PRE-K/K (ECC) AND ELEMENTARY SCHOOL RENOVATIONS

**Addendum #2
March 30, 2020**

STAFFORD MUNICIPAL SCHOOL DISTRICT

PRE-K/K (ECC) AND ELEMENTARY SCHOOL RENOVATIONS – ADDENDUM #2

1 ENLARGED MECHANICAL DEMO PLAN
 SCALE: 1/8" = 1'-0"
 NORTH

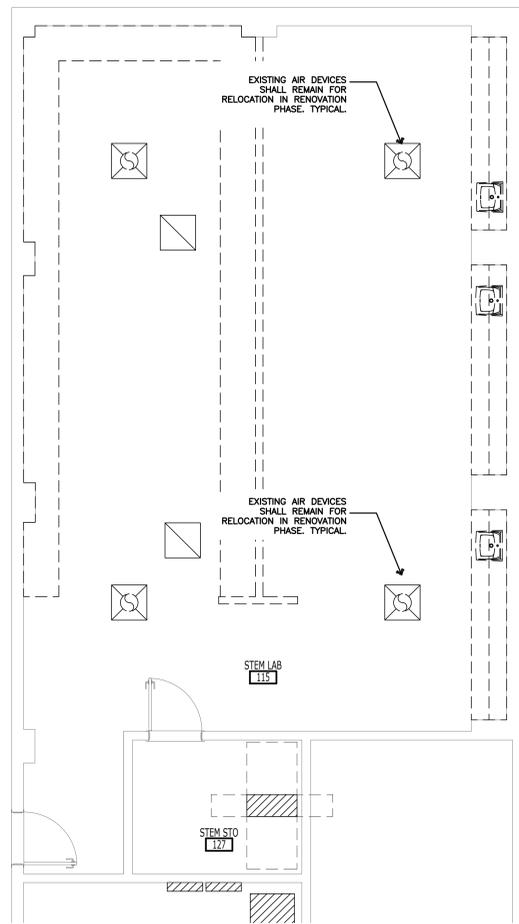
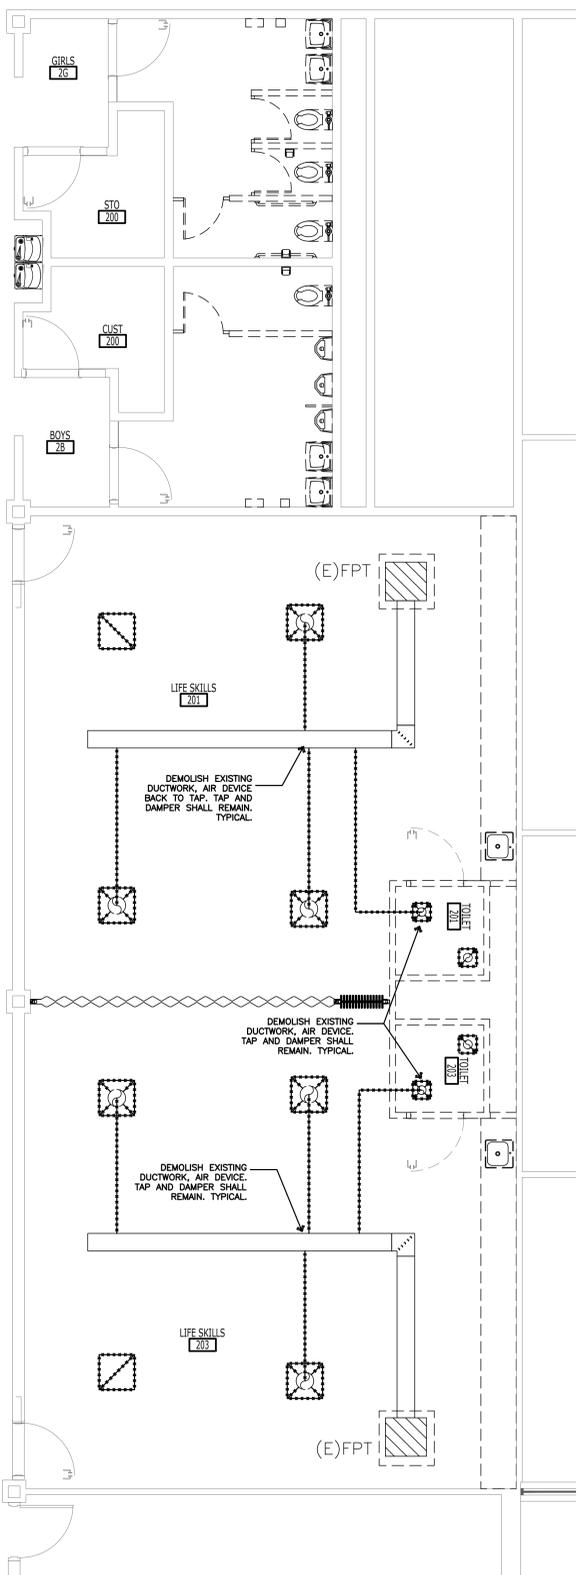
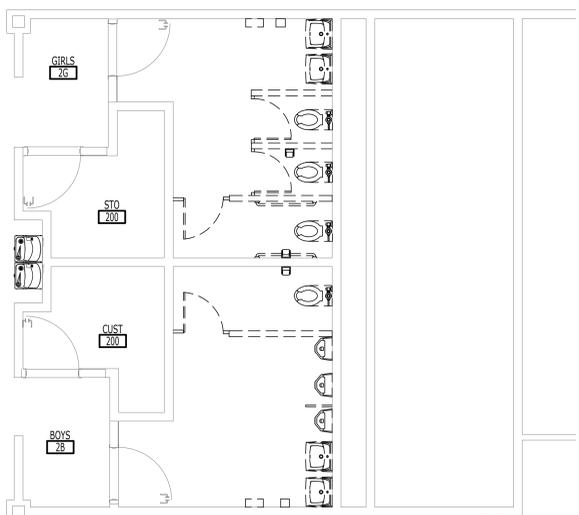
- Item 11.** Sheet MD01-01 (ES)
- a. Full size sheet re-issued.
 - b. Tags for existing terminal units have been updated.
 - c. Demolish existing terminal unit serving main library space.

MECH. DEMO PLAN
 -CONTROLS UPDATE
MD01-02

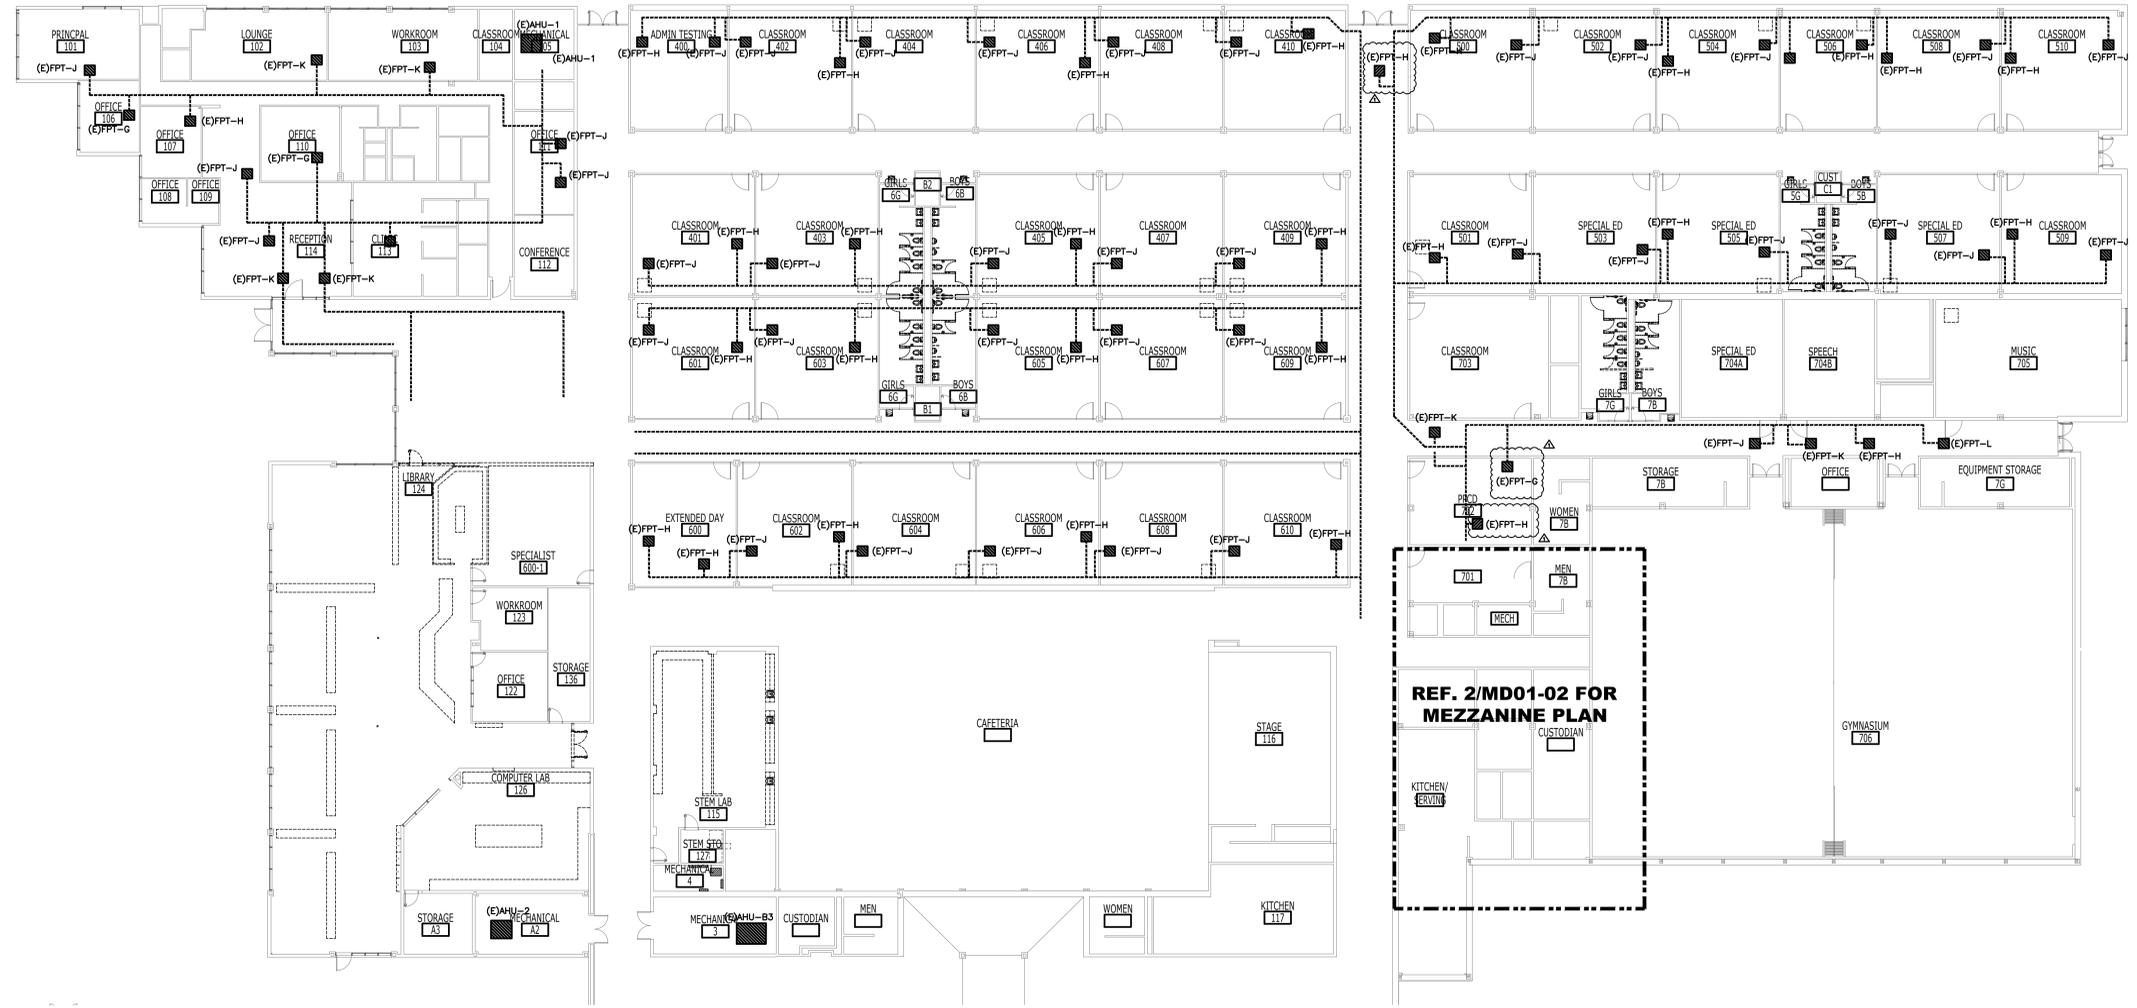
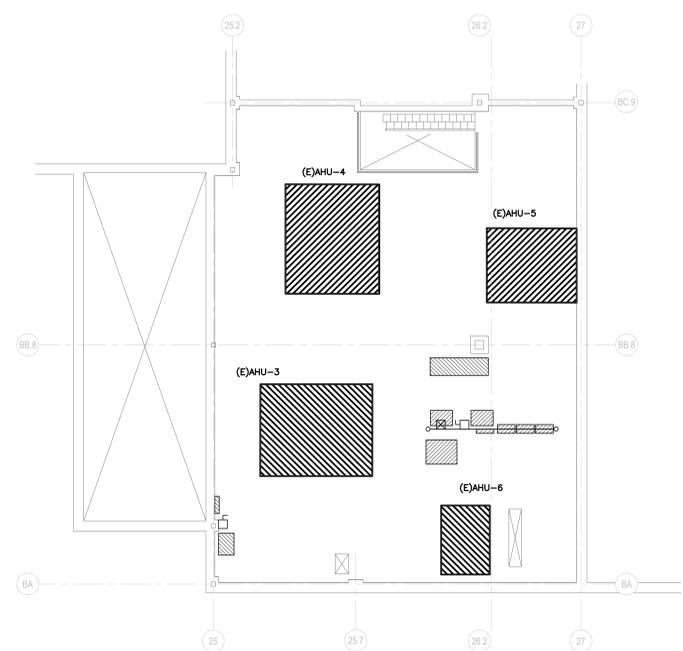
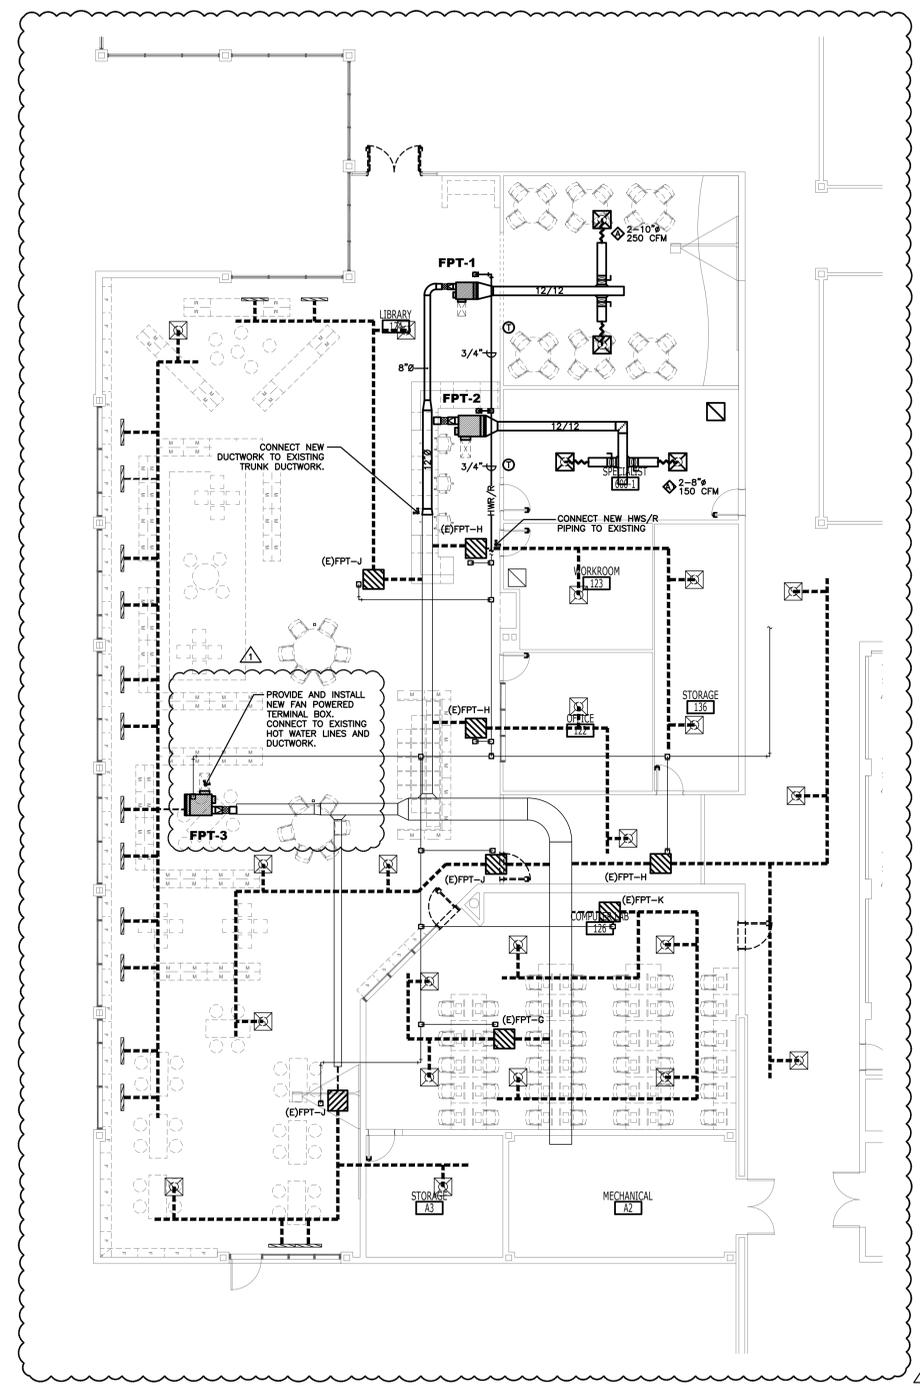
- Item 12.** Sheet MD01-02 (ES)
- d. Full size sheet re-issued.
 - e. Tags for existing terminal units have been updated.
 - f. Three (3) additional terminal units have been added to the scope. Total of seventy four (74) units are now referenced in view.

1 MECHANICAL FLOOR PLAN-CONTROLS UPDATE
 SCALE: 1/16" = 1'-0"

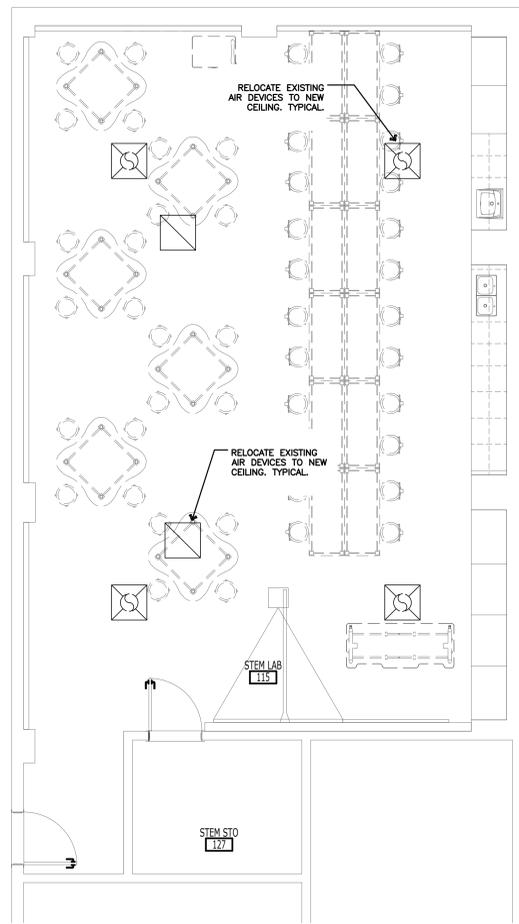
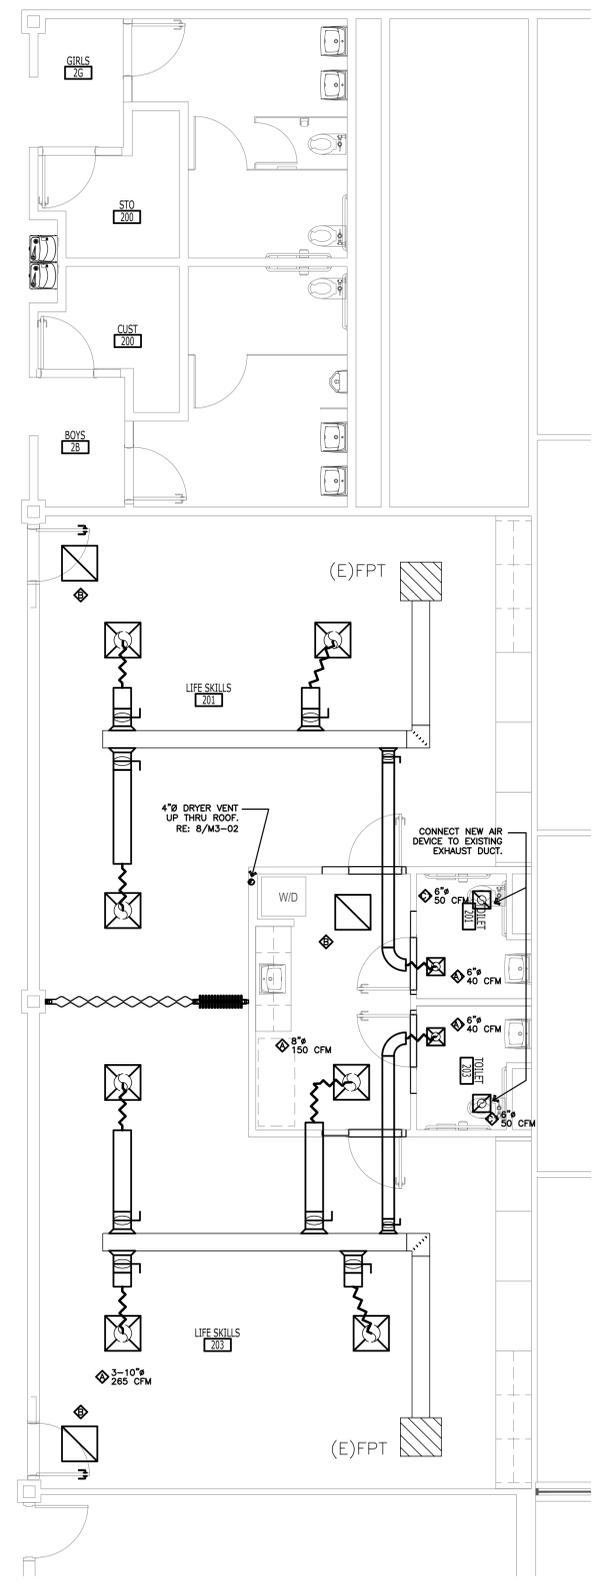
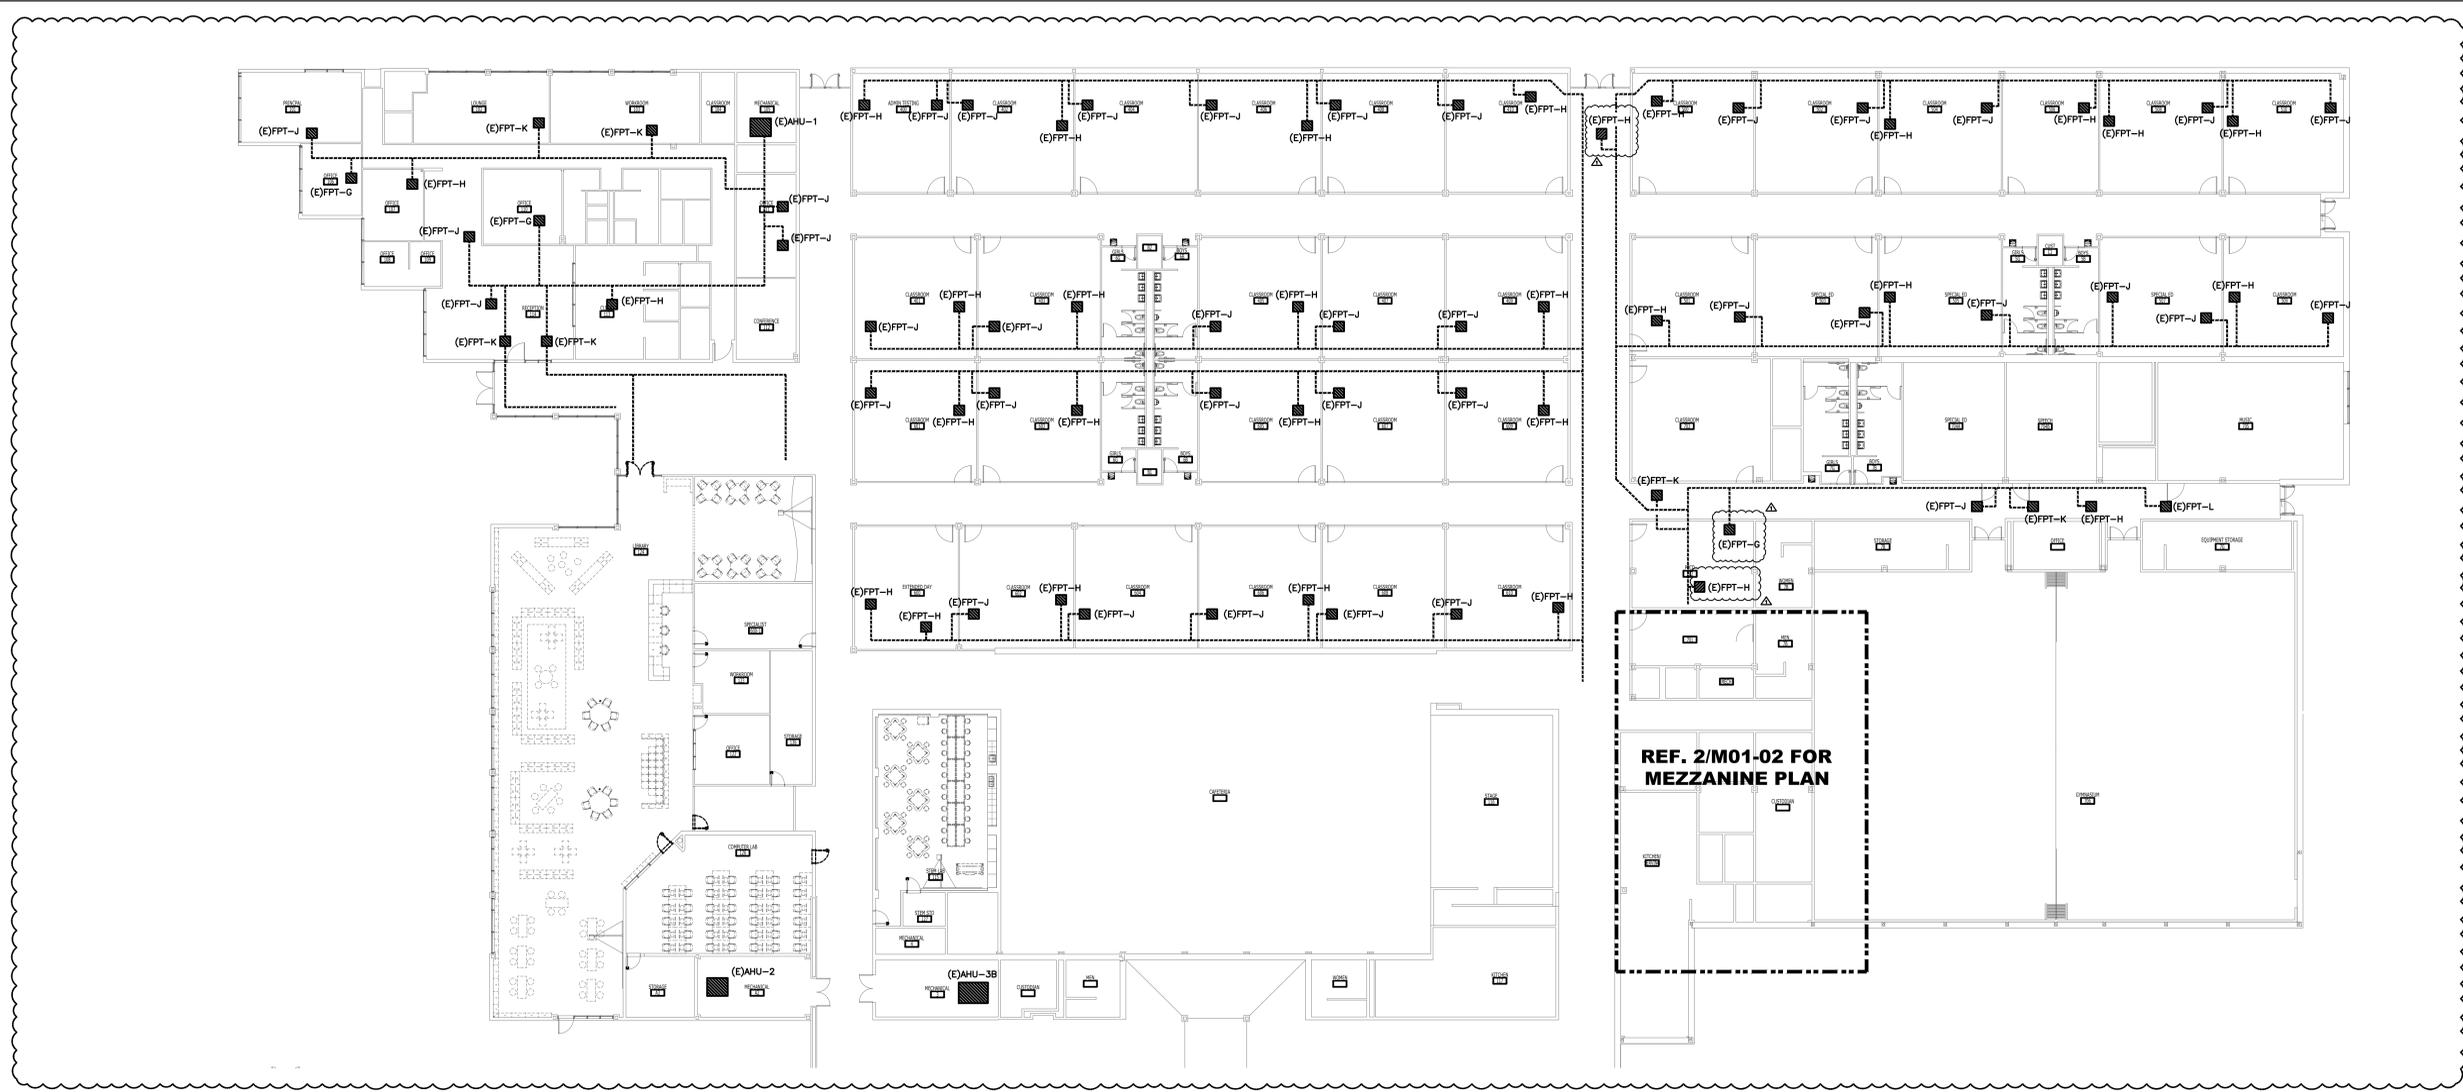
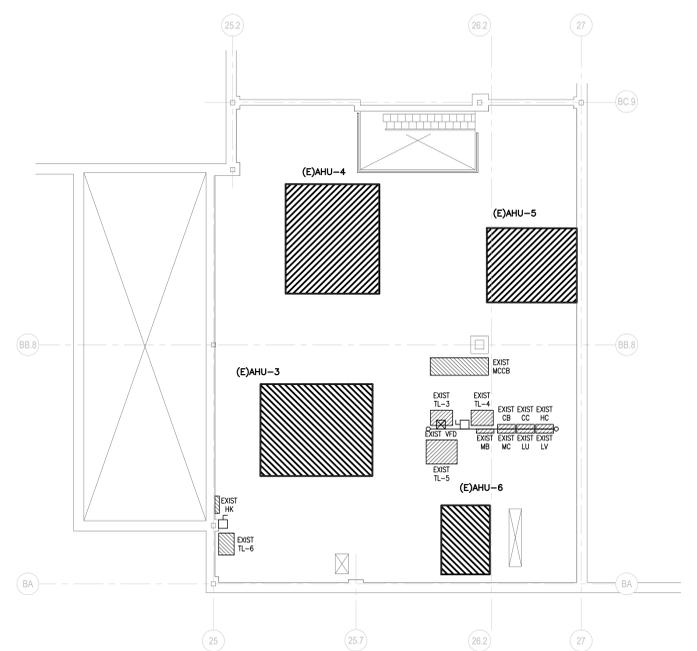
- Item 13.** Sheet M01-01 (ES)
- g. Full size sheet re-issued.
 - h. Tags for existing terminal units have been updated.
 - i. Note #8 added to "FAN POWERED BOX CONTROLS" schedule.

- i. 8. INSTALL TITUS EXX ROUND RETROFIT TERMINAL KIT ON ALL EXISTING FAN POWERED TERMINAL BOXES. REFER TO UNIT TAG AND RETROFIT TERMINAL KIT SCHEDULE FOR SIZES AND FLOW.

- j. Provide new fan powered terminal unit FPT-3 to serve main library space.
- Item 14.** Sheet M01-02 (ES)
- k. Full size sheet re-issued.
 - l. Tags for existing terminal units have been updated.
